APPLICATION FOR PERMIT TO DRILL OR REENTER

CASCADE 28 FEDERAL  
74H

2. Name of Operator  
CIMAREX ENERGY COMPANY

COA

Figure 1. Cross-sections and plans for typical road sections representative of BLM resource or FS local and higher-class roads.

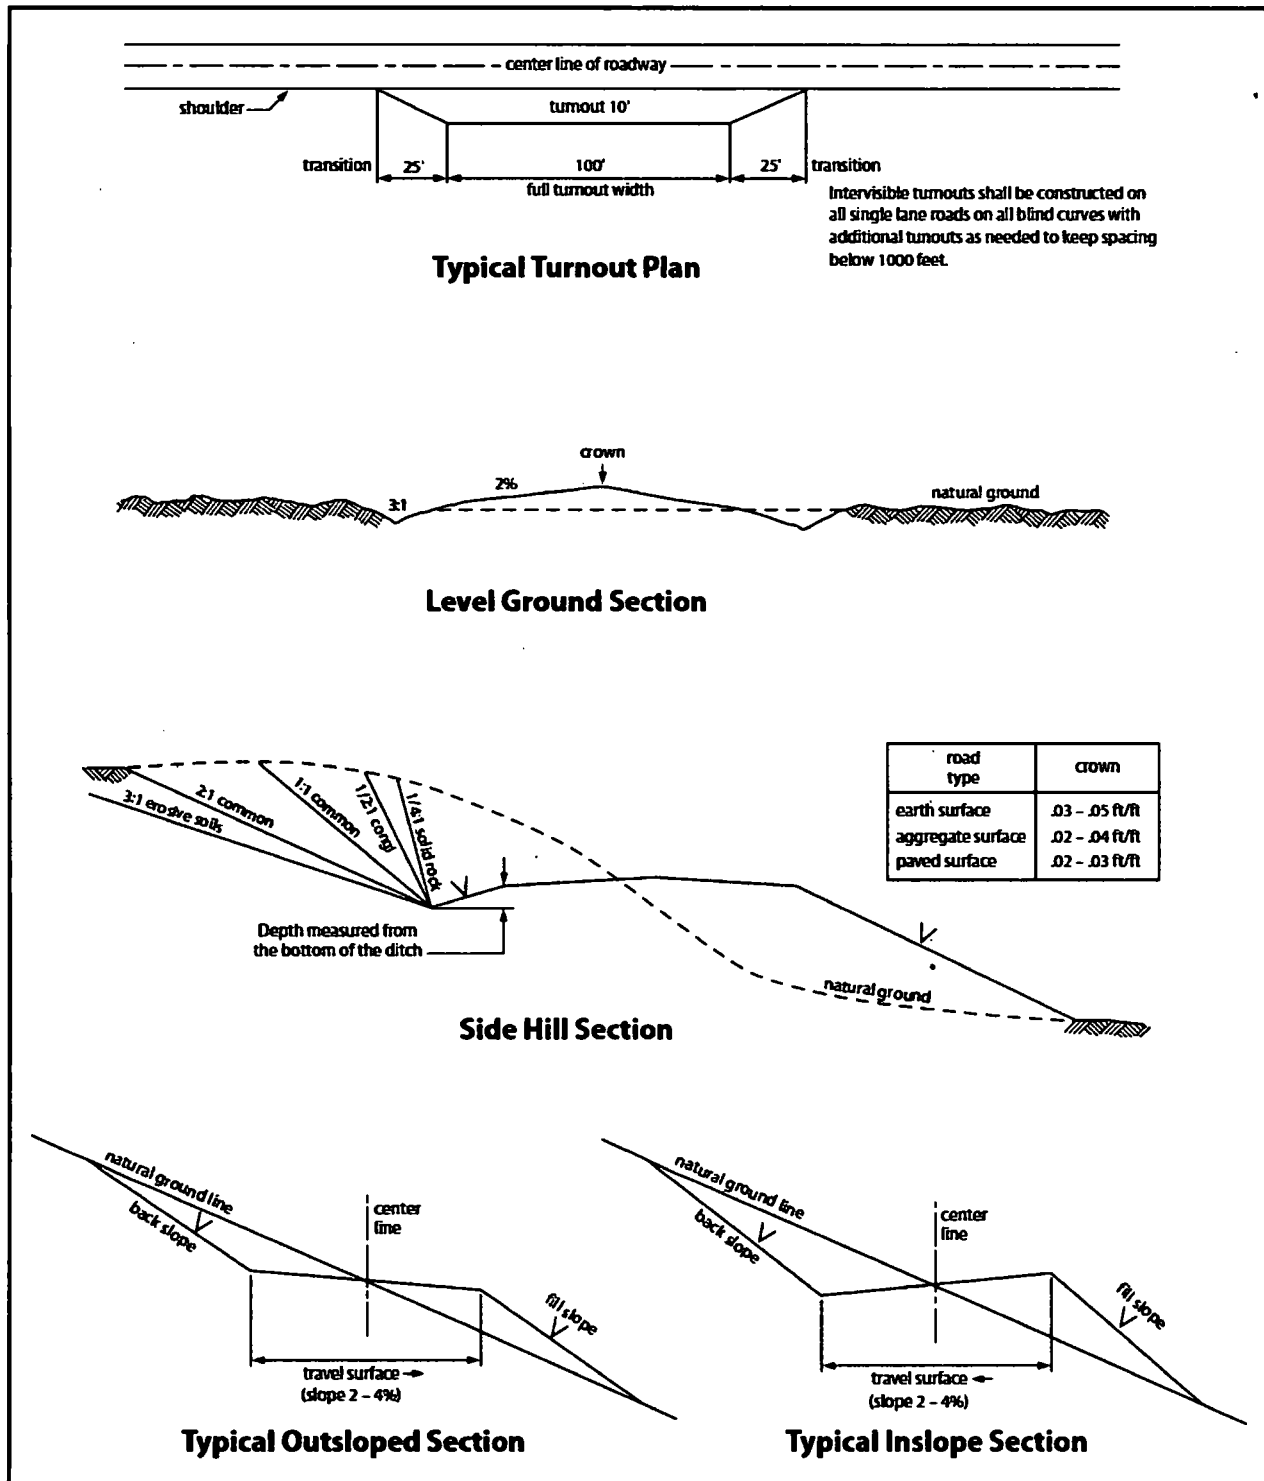
Crowning shall be done on the access road driving surface. The road crown shall have a grade of approximately 2% (i.e., a 1" crown on a 14' wide road). The road shall conform to Figure 1; cross section and plans for typical road construction.

Vehicle turnouts shall be constructed on the road. Turnouts shall be intervisible with interval spacing distance less than 1000 feet. Turnouts shall conform to Figure 1; cross section and plans for typical road construction.
